Subject: Application for Amendment to Facility Operating License  
Revision to Safety Limits and Instrumentation Setpoints  
Rochester Gas & Electric Corporation  
R.E. Ginna Nuclear Power Plant  
Docket No. 50-244

The enclosed License Amendment Request (LAR) proposes to revise the Ginna Station Improved Technical Specifications (ITS) associated with Safety Limits (Section 2.1), Instrumentation (Sections 3.3.1, 3.3.2, 3.3.4, and 3.3.5), and the Core Operating Limits Report (COLR) (Section 5.6.5).

**Marked up Copy of R.E. Ginna Nuclear Power Plant  
Improved Technical Specifications and COLR**

Figure 2.1.1-1  
Reactor Safety Limits

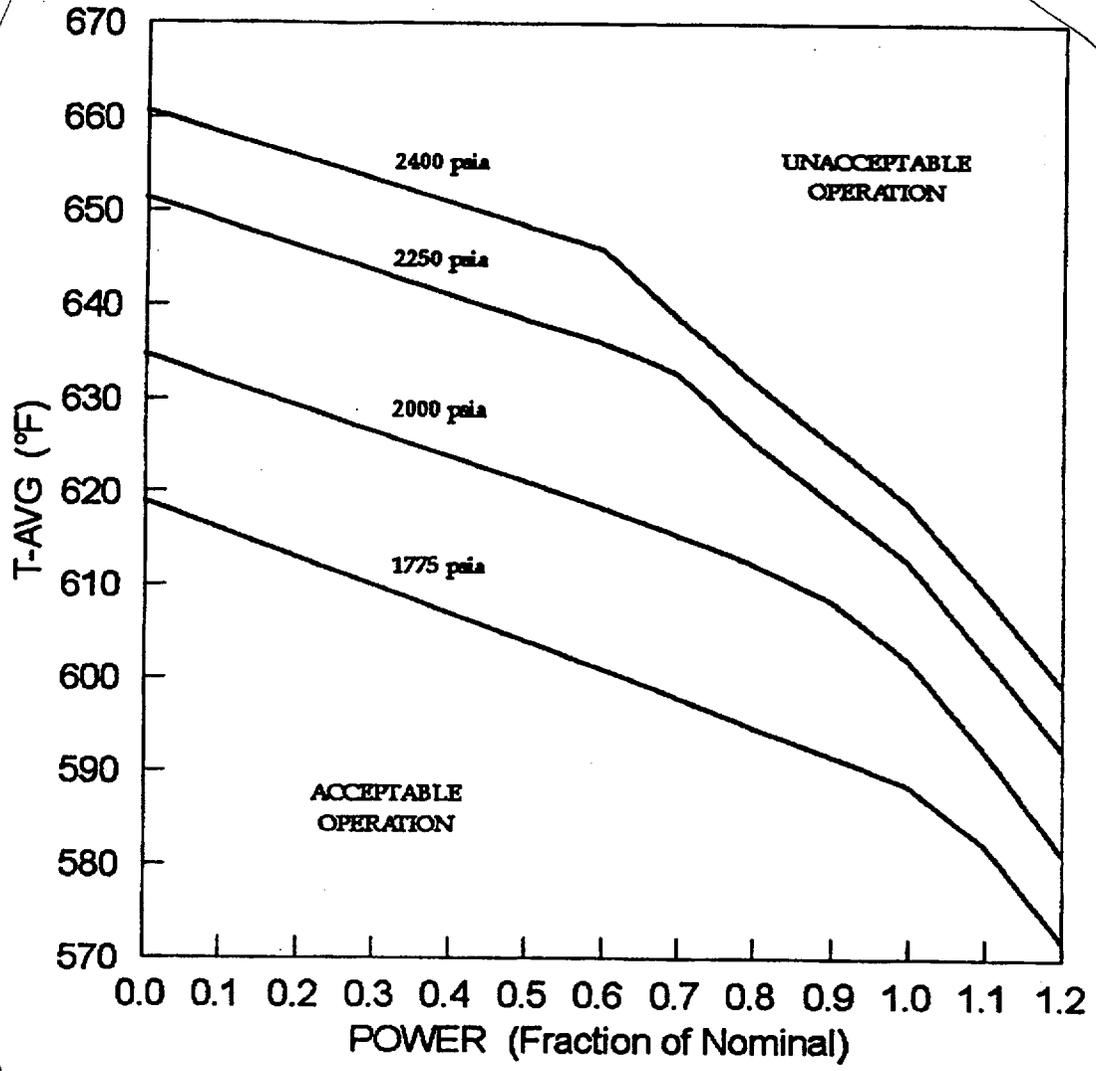
1. The Reactor Safety Limits Figure 2.1.1-1 is being relocated to the COLR consistent with NUREG-1431 and NRC-approved traveler, TSTF-339 Revision 2,

1. 2.1
  - a. The Reactor Safety Limits Figure 2.1.1-1 is being relocated to the Core Operating Limits Report (COLR). The figure is being replaced with limits for departure from nucleate boiling ratio (DNBR) and peak fuel centerline temperature. This change is consistent with WCAP-14483-A (Reference 1), NUREG-1431 (Reference 2), and TSTF-339 Revision 2.

- R.1 ITS Reactor Safety Limits (RSL) Figure 2.1.1-1 is being relocated to the Core Operating Limits Report (COLR), and the limits for departure from nucleate boiling ratio (DNBR) and peak fuel centerline temperature are being added to LCO 2.1.1 in its place. The most significant reason for replacing the RSL figure is that there are limitations associated with the figure that could result in drawing an incorrect conclusion with respect to the DNB design basis. Drawing a correct conclusion with respect to the safety limits is an important consideration given the ramifications associated with the violation of a safety limit. As noted in WCAP-14483-A (Reference 1), the violation of a safety limit could only result if the reactor protection system were not functioning as designed. The reactor protection system and main steam system safety valves ensure that all the safety limits will be met, independent of the RSL figure. Using the figure to determine whether or not a safety limit had been violated is marginal at best. In the event of a Condition I or II transient, verification that the reactor protection system and the main steam system safety

It is proposed that the RSL figure be relocated to the COLR (Specification 5.6.5) and be replaced with the DNBR design basis limit and the fuel centerline melting limit, which are taken from the Ginna Station UFSAR. Both of these limits are criteria that must be satisfied for all Condition I and II transients. Confirmation that the reactor protection system and the main steam system safety valves are functioning as designed will ensure that both the DNB design basis and fuel centerline melting criteria are satisfied for any Condition I or II event. With this approach, the chance of reaching an incorrect conclusion with respect to the safety limits would be greatly reduced, if not eliminated. It should be noted that using the DNBR and fuel centerline melting criteria, in combination with ensuring compliance with the TS prior to the initiation of an event, satisfies 10CFR50.36 and is also consistent with NUREG-1431, Revision 2.

2.1.1.1 The departure from nucleate boiling ratio (DNBR) shall be maintained  $\geq 1.17$  for the WRB-1 correlation.

2.1.1.2 The peak fuel centerline temperature shall be maintained  $< 5080^{\circ}\text{F}$ , decreasing by  $58^{\circ}\text{F}$  per 10,000 MWD/MTU of burnup.
